SUNDRY NOTICE

1. OGCC Operator Number: 78110 API Number: _____
2. Name of Operator: SWEPI LP OGCC Facility ID # 425501
3. Well/Facility Name: HART GULCH Well/Facility Number: 1-17
4. Location (QtrQtr, Sec, Twp, Rng, Meridian): NWSE, 17-4N-90W-6M

SWEPI, LP is submitting a sundry to request a change in surface location for the Hart Gulch 1-17 well. SWEPI proposes to move the surface hole location of the Hart Gulch 1-17 well towards the center of the pad in order to reduce safety issues and to better fit the rig on the pad. The following are changes to the Form 2a in addition to the information listed on pg 1 of Form 4:

HYDROLOGY
MAP

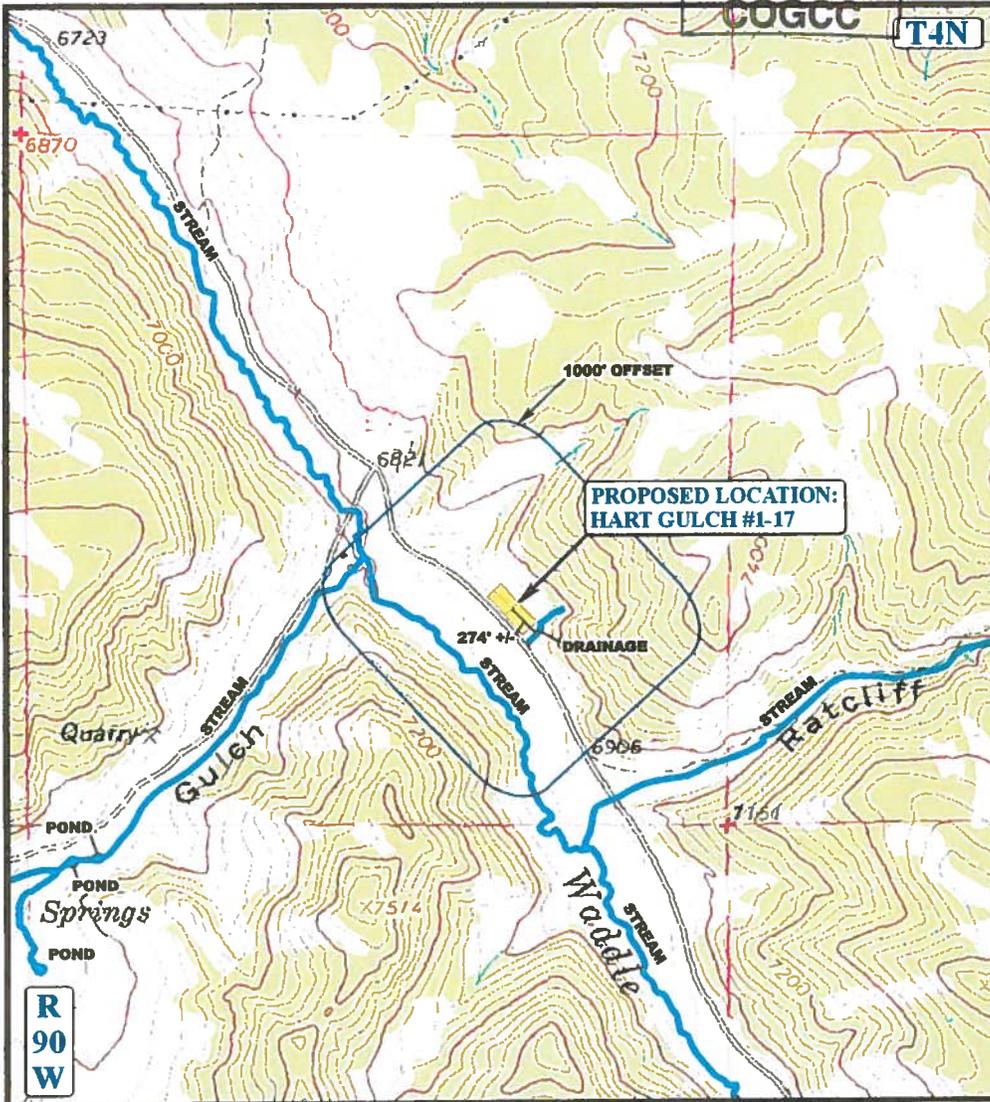
- Hydrology Map: Hart Gulch 1-17
- Location Drawing: Hart Gulch 1-17
- Construction Layout Drawing: Hart Gulch 1-17
- Reference Area Map: Hart Gulch 1-17
